## Roadster 2010-12 en Fuel Vapor Canister Vent Hose Inspection/Replacement

Bulletin type: **Safety Campaign**

Bulletin no: **2010-12** (rbg2010-013 en AP)

Subject: **Fuel Vapor Canister Vent Hose Inspection/Replacement**

- 1. Fuel canister vent hose

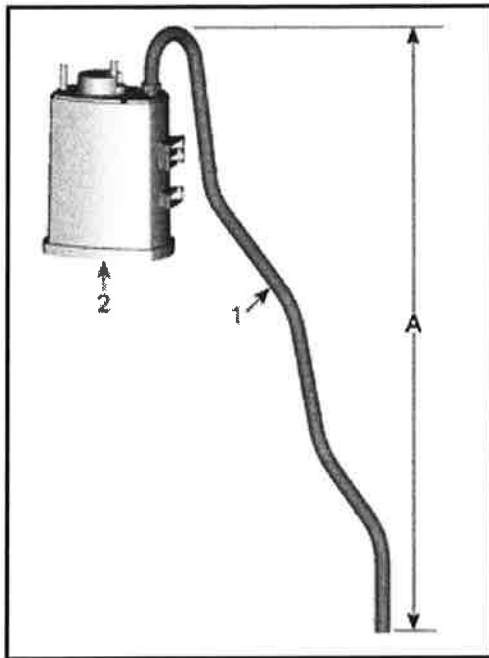
Visually inspect the fuel vapor canister vent hose.

#### FUEL VAPOR CANISTER VENT HOSE

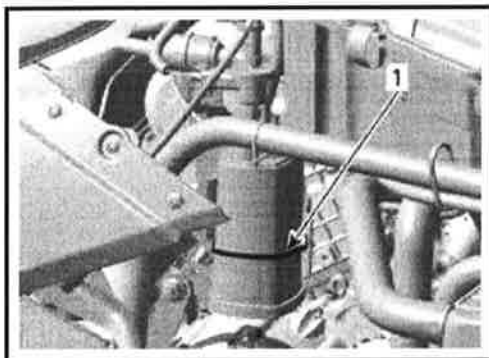
If the correct hose is installed and properly routed, no future action is required. This hose is preformed and must have the following shape. Reinstall all removed parts and go to WARRANTY procedure.

If another hose is installed, remove and discard it before installing the correct hose.

1. Preformed vent hose (P/N 709 000 277)

A. Approximately 480 mm (18-7/8 in)

1. Install grommet here

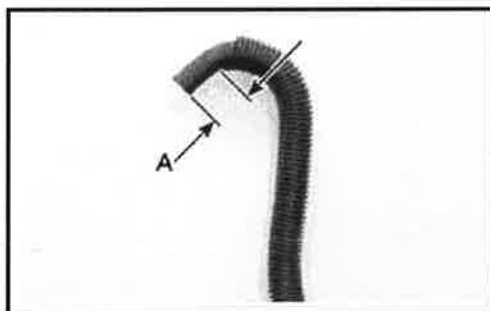
- 2. Move radiator backward as far as possible from its location.
- 3. Install grommet into chassis hole as shown.

1. Hose behind canister  
2. Hose behind coolant hose

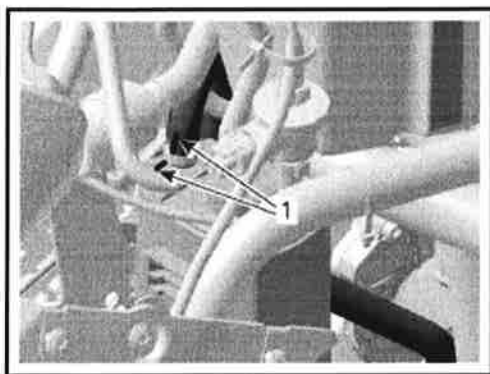
5. Route vent hose from grommet to canister as shown.

1. Alignment marks on canister and vent hose

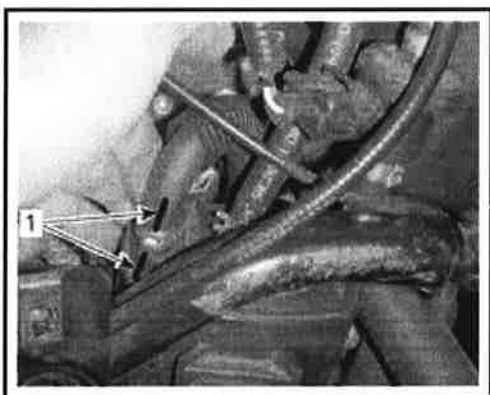
6. Loosely install vent hose and its clamp onto canister. DO NOT TIGHTEN CLAMP YET.

7. TEMPORARILY INSTALL canister in its support.

8. Rotate vent hose so that it is properly located.

9. Trace a mark on vent hose.

10. Trace a second mark on canister aligned with the first mark.
